Computerized Thermal Imaging, Inc.

Breast Cancer System 2100

PMA P010035

Amendment 6

- b) Flowcharts are presented on the following pages for the three sets of subjects used in primary efficacy analyses – PMA and PPMA subjects combined, and PMA (Amendment 4) subjects and PPMA (Amendment 5) subjects presented separately.

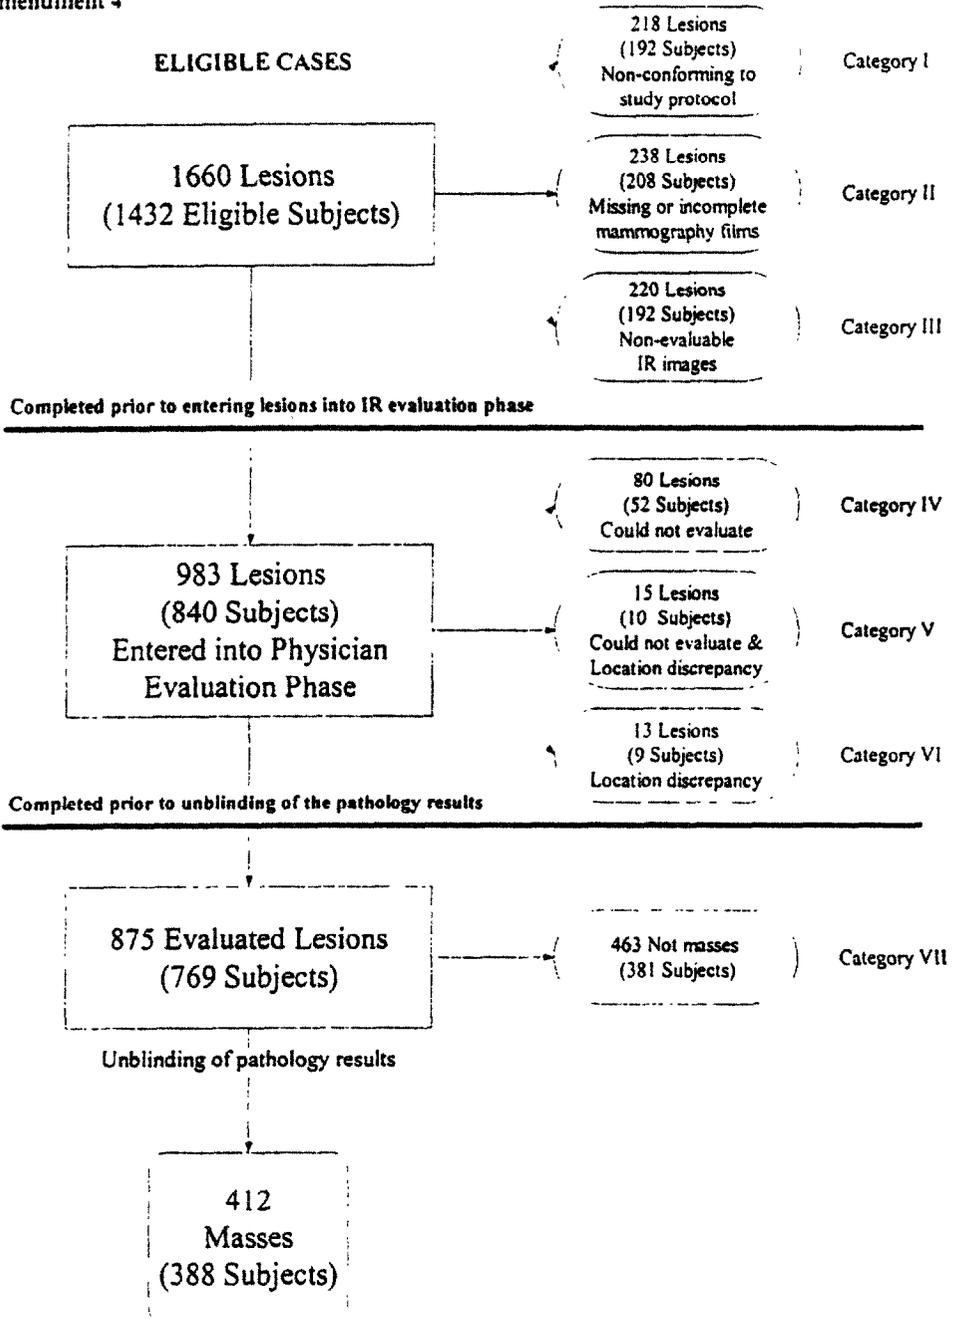
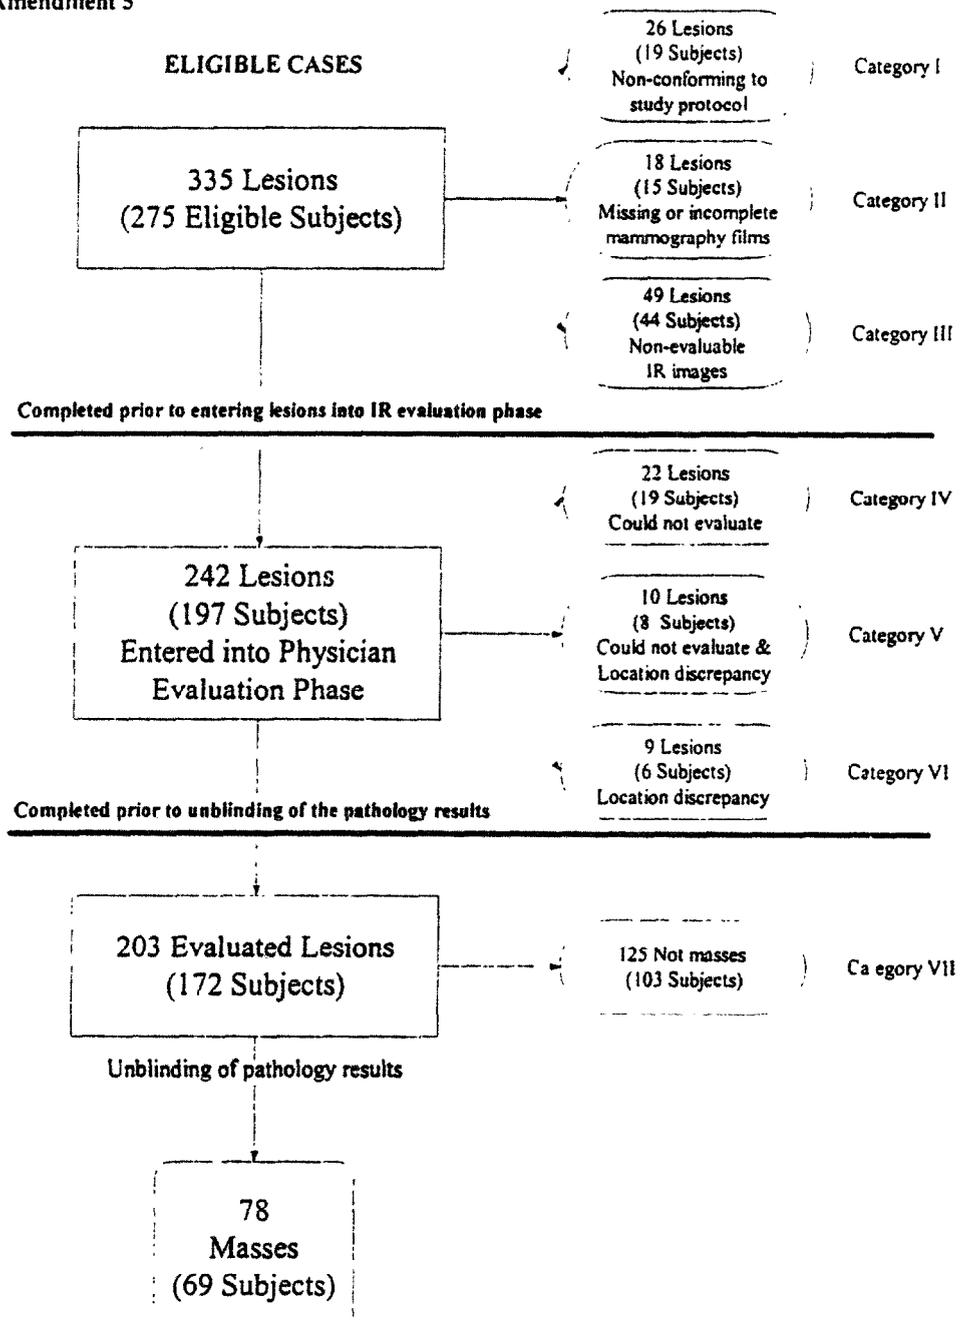
b) In addition to verbal description, please also present this information in the form of a flow chart, with the numbers of i) subjects and ii) lesions following each pathway in the chart and a categorization of each of the pathways.
